**PLANNING COMMISSION STAFF REPORT
MAJOR SUBDIVISION SMF2023 0003
HEARING DATE: AUGUST 22, 2023**

PROPOSAL: Applicant requests a Final Plat review for a private shared access subdivision of the Blacktail Mountain Estates, Tract B into four (4) lots, with access via Wee Burn Drive.

Project Description – Following the approval of preliminary plat SMP2021-0008, the applicant is finalizing the subdivision of Tract B of Blacktail Mountain Estates into four (4) private shared access lots (**Attachment A**).

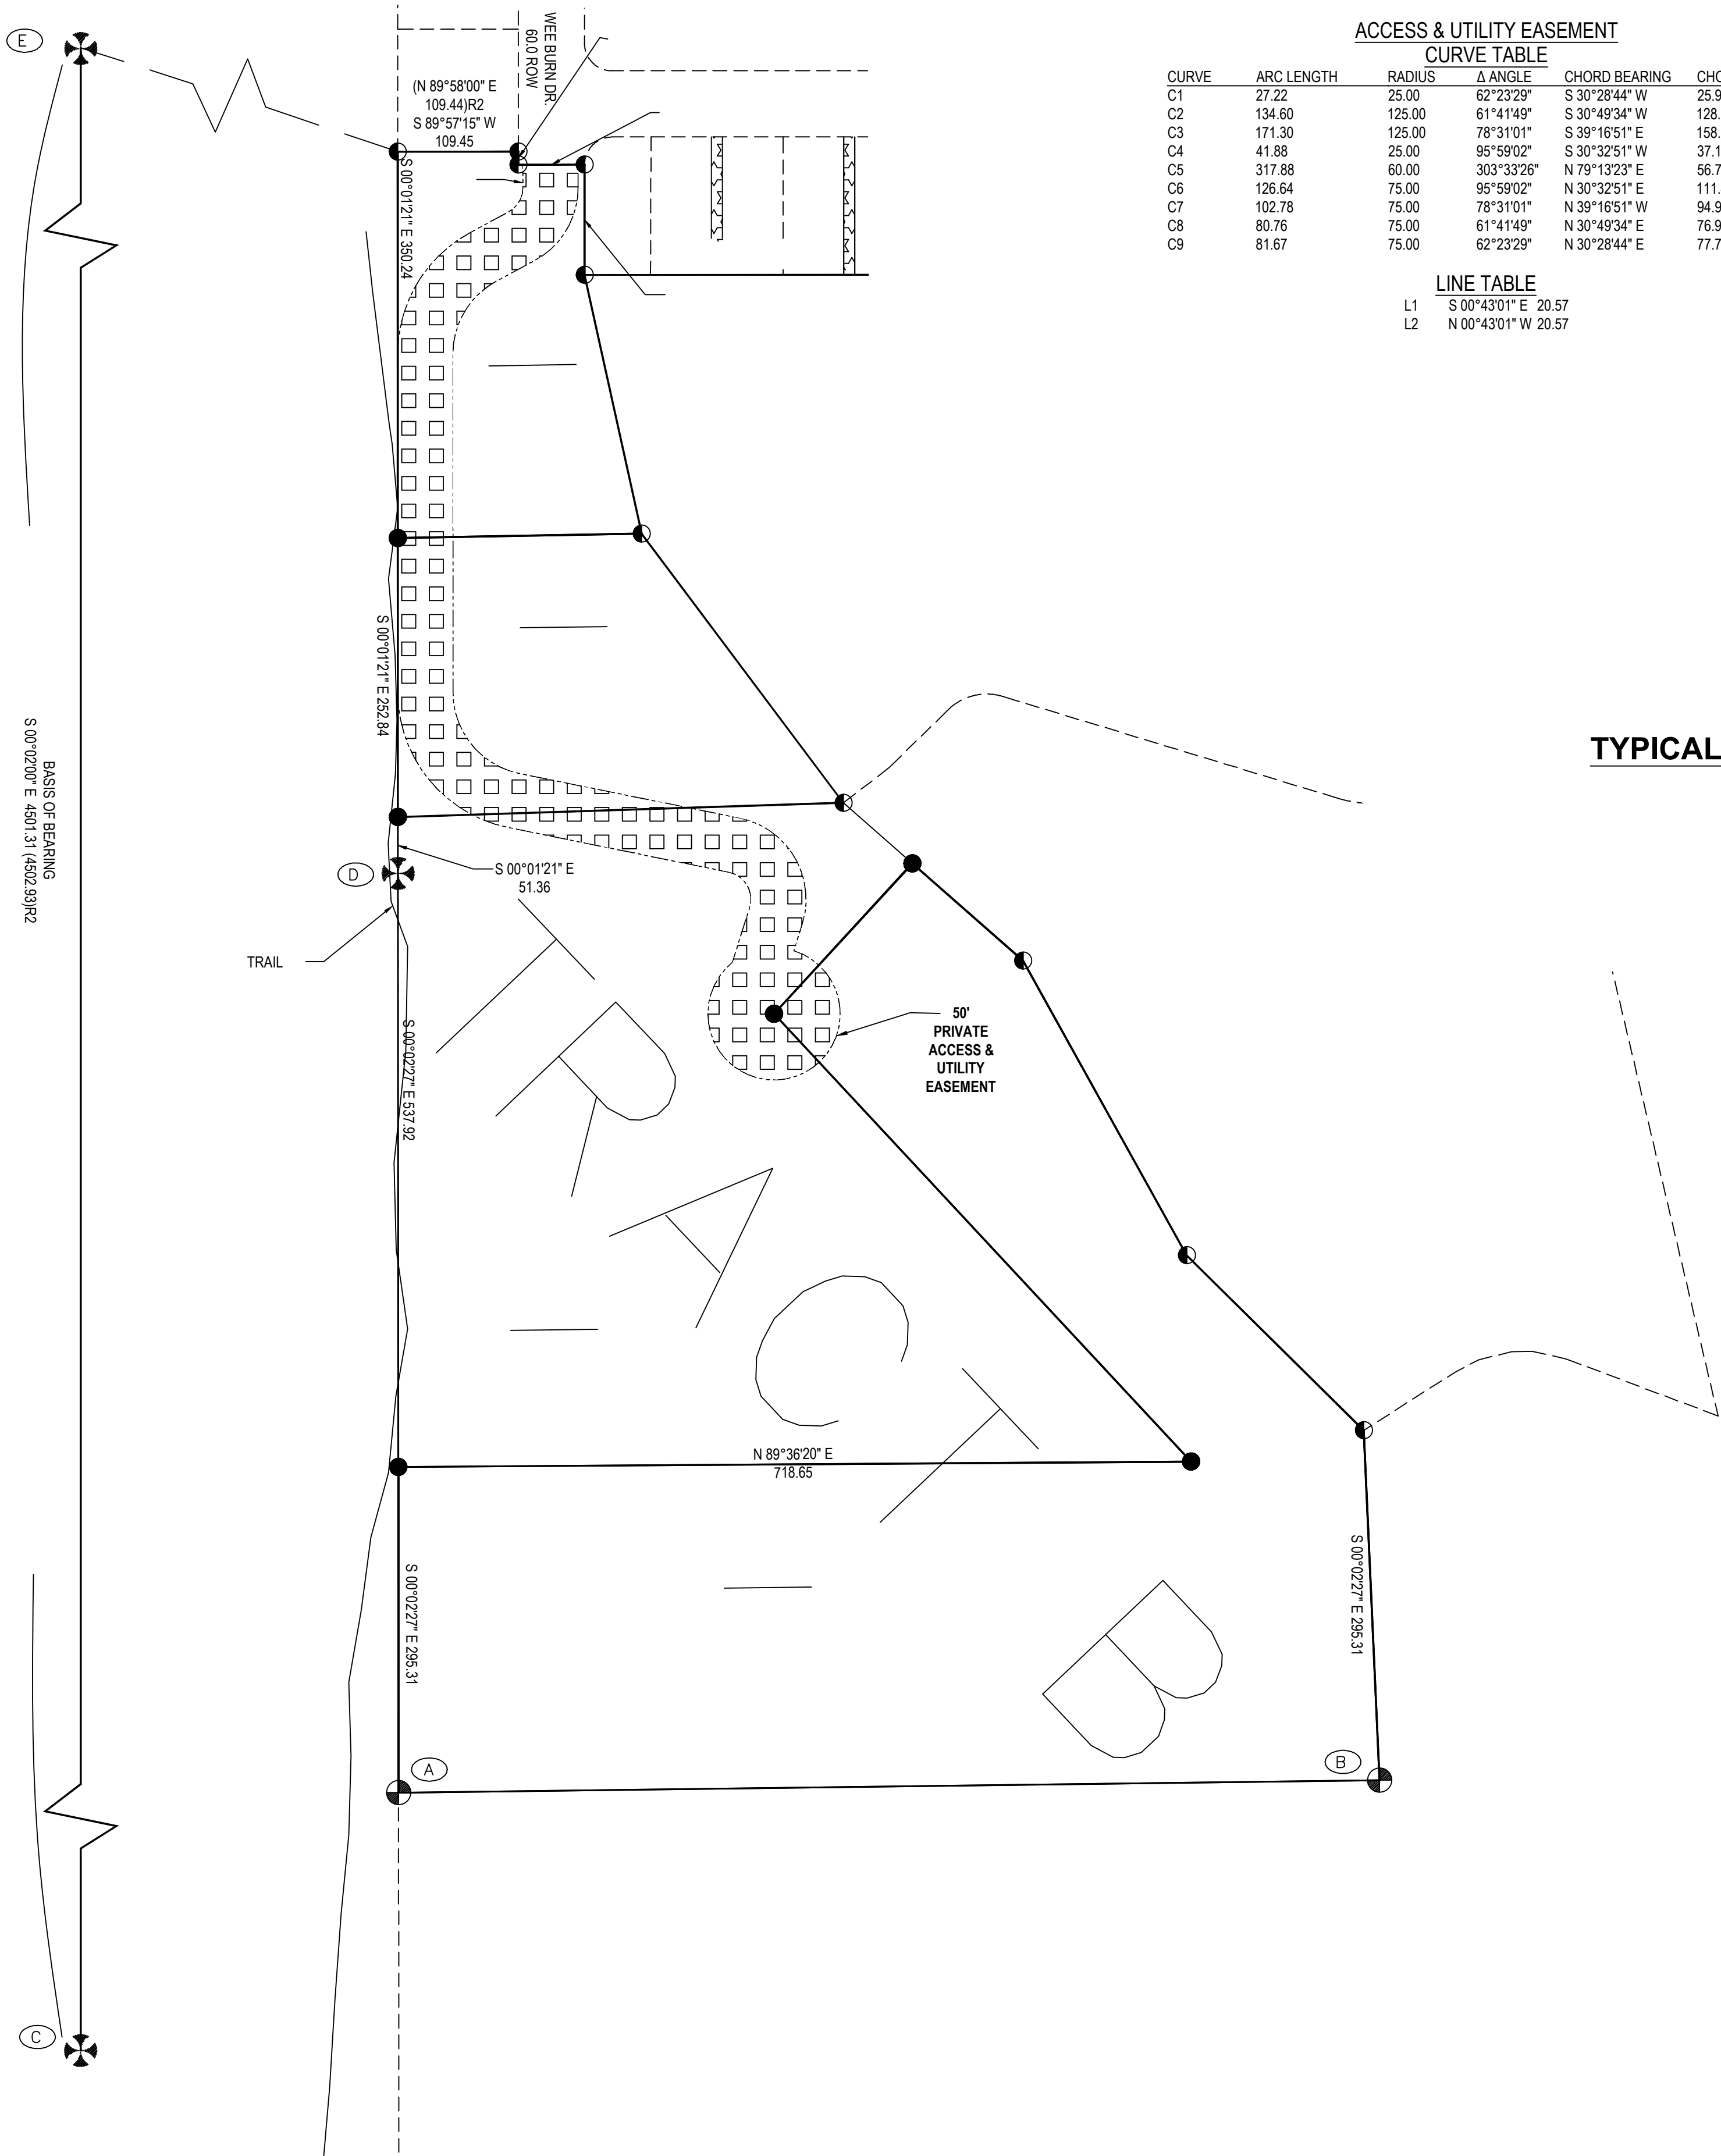
1. Tract B
 - a. Sheet 1
 - i. Remove Basis of Bearing detail and show monuments on line with line breaks, it is unclear as it is currently shown.
 - ii. Place "Tract B" in dashed text across the original tract.
 - iii. Describe "Tract A" and "Tract C" on plat body with "Plat No 2021-32 JRD".
 - iv. Rephrase Park Site A to read, "PARK SITE A, PLAT No. 84-110 JRD".
 - v. Show street names in vicinity sketch.
 - vi. Add "drainage" to access and utility easement.
 - vii. East boundary of Lot B4 needs bearing and distance.
 - viii. Add driveway easement linetype and hatch.
 - ix. Remove 10' access easement from legend.

- b. Sheet 2
 - i. In basis of bearing statement, change Chilkat Monuments to GLO monuments.
 - ii. Change all signatory dates to 2022.
 - iii. Remove set primary monument detail.
 - iv. Monument details C and D should read Pipe instead of Pine.
 - v. Change plat name in title block to match Sheet 1 as shown above.
 - vi. Can remove legend and scale bar this sheet.
 - vii. Use this access note for private shared access subdivisions (CBJ49.35 DIVISION 2) (i.e. access to 1 or more lots is via an easement and some lots have no right of way frontage)

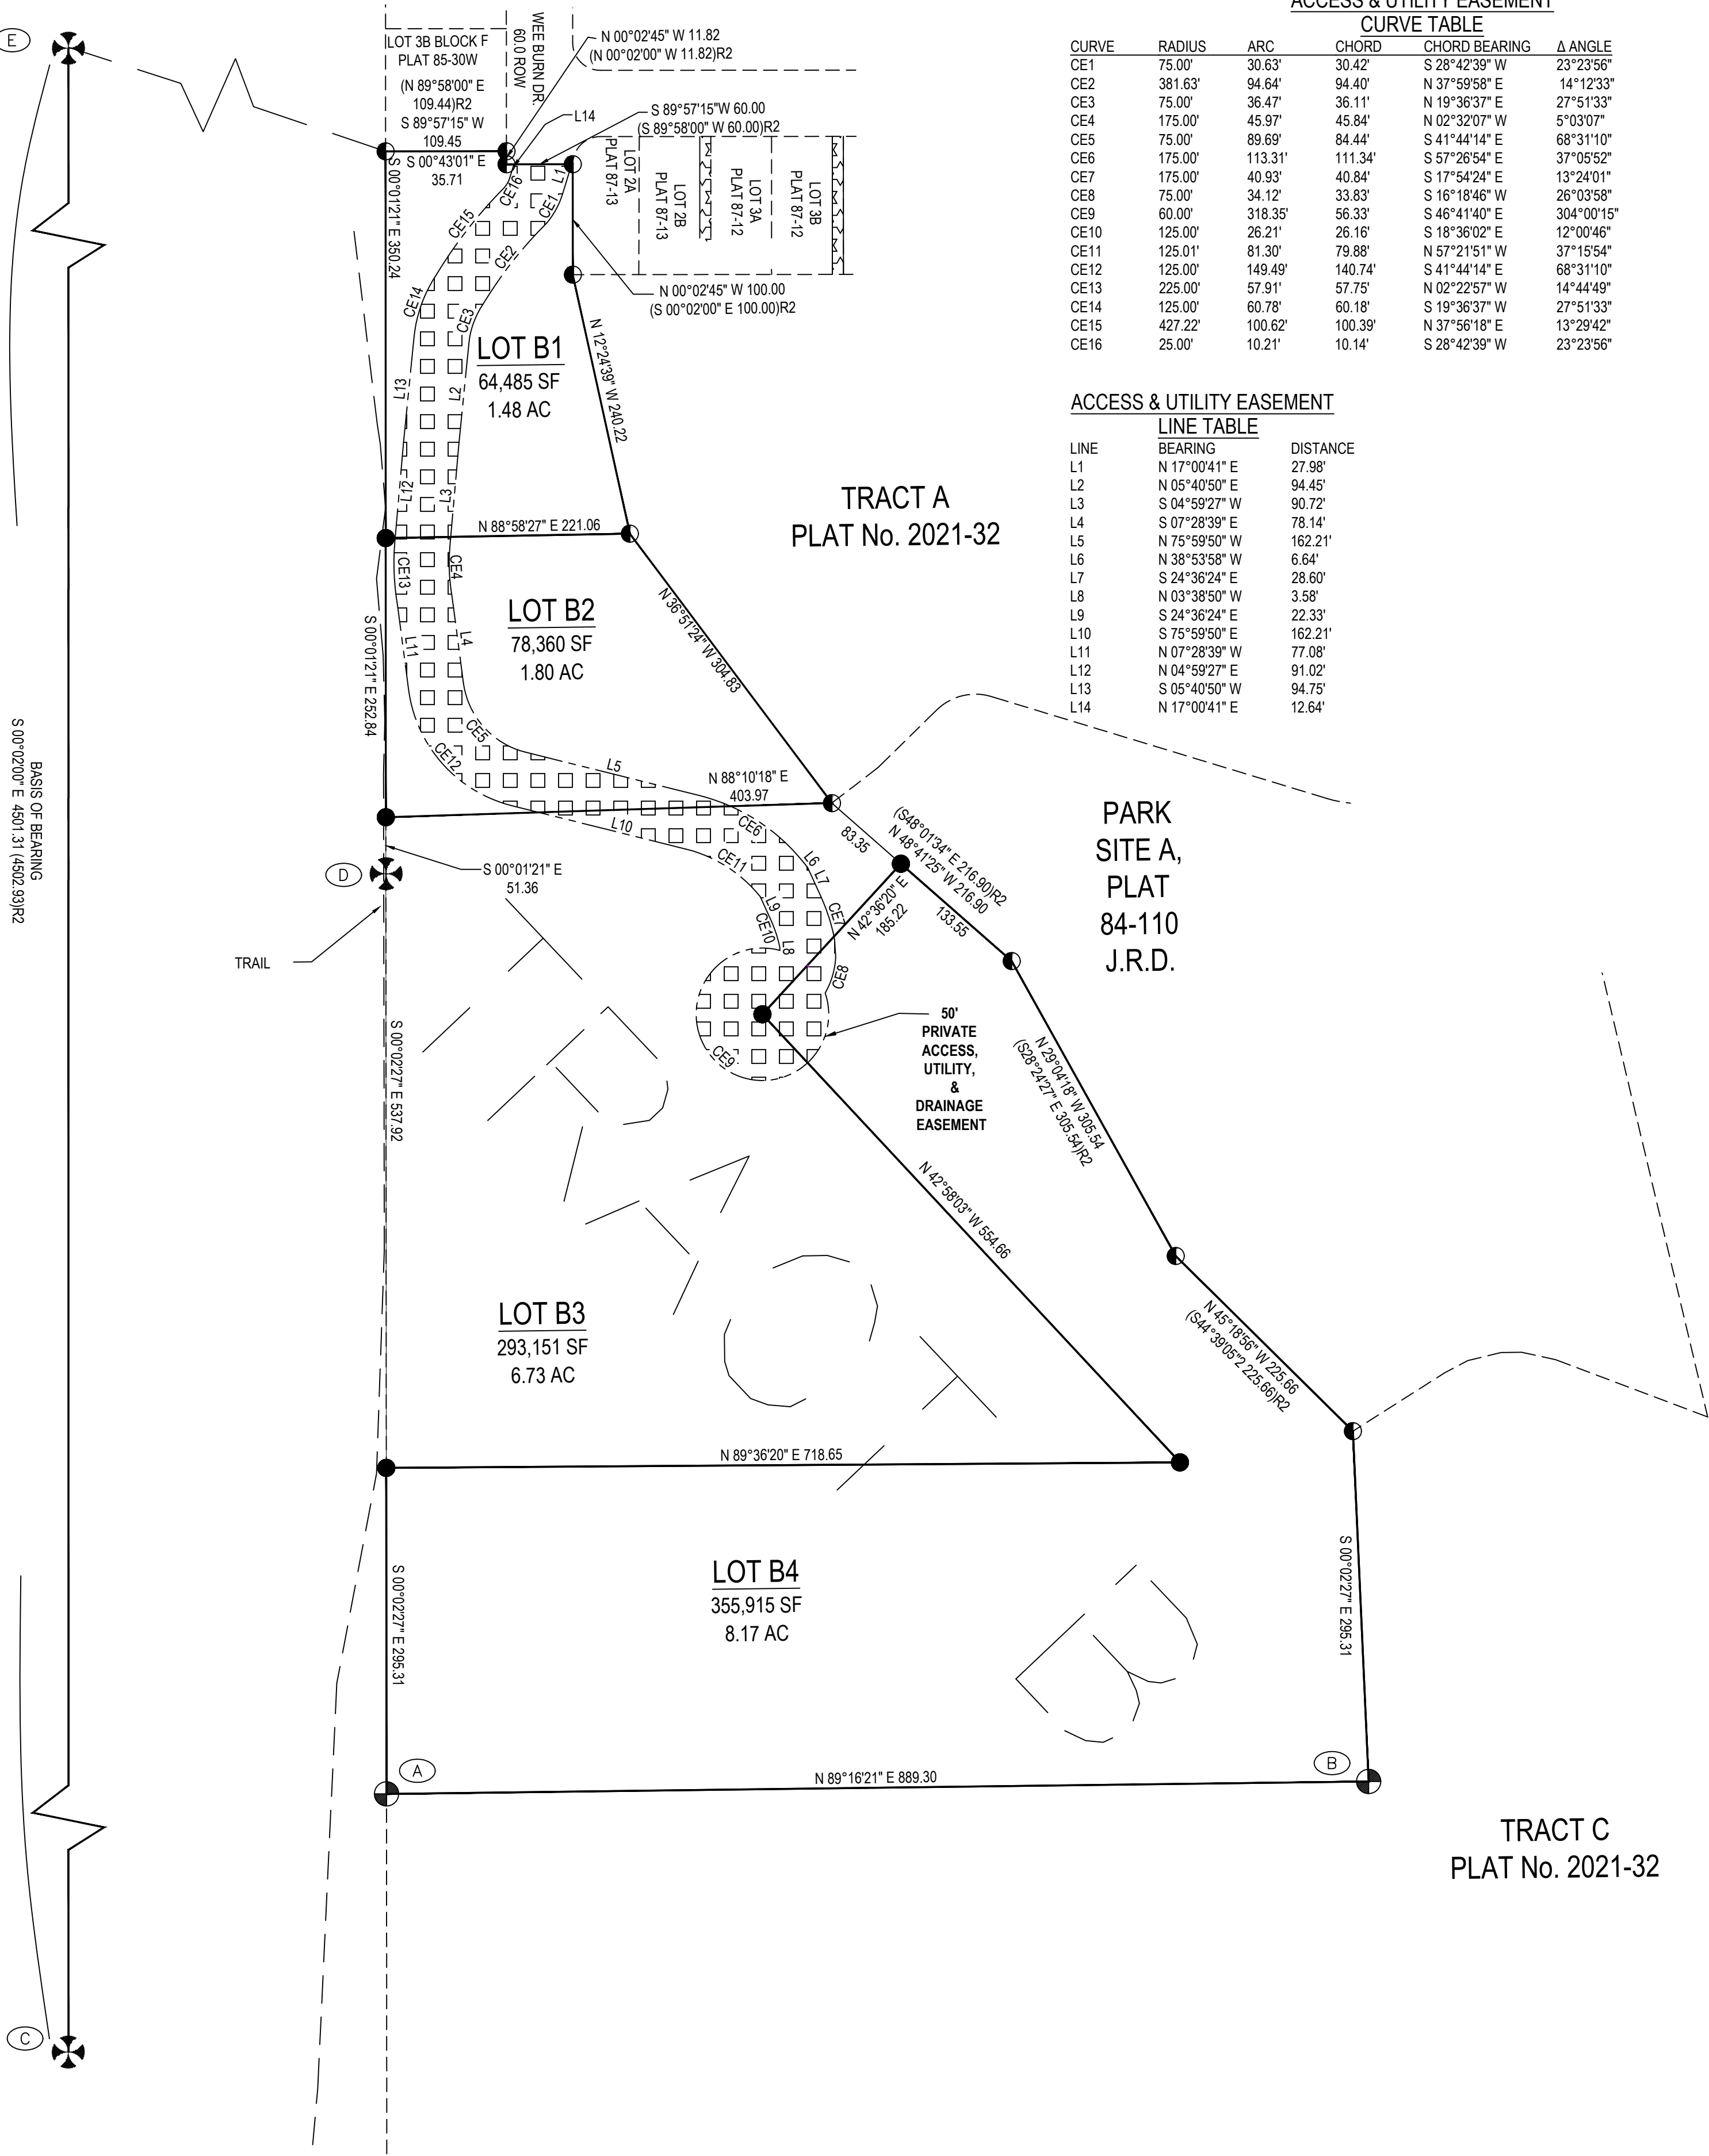
1. Revise the trail line type so it differs from the property lines.
2. On sheet 2, revise "SHEET NO. 1 of 2" to "SHEET NO. 2 of 2".
3. In the Ownership Certificate for Peter Peel, revise "OWNERS" to "OWNER".
4. Revise the line below to the dashed line type.
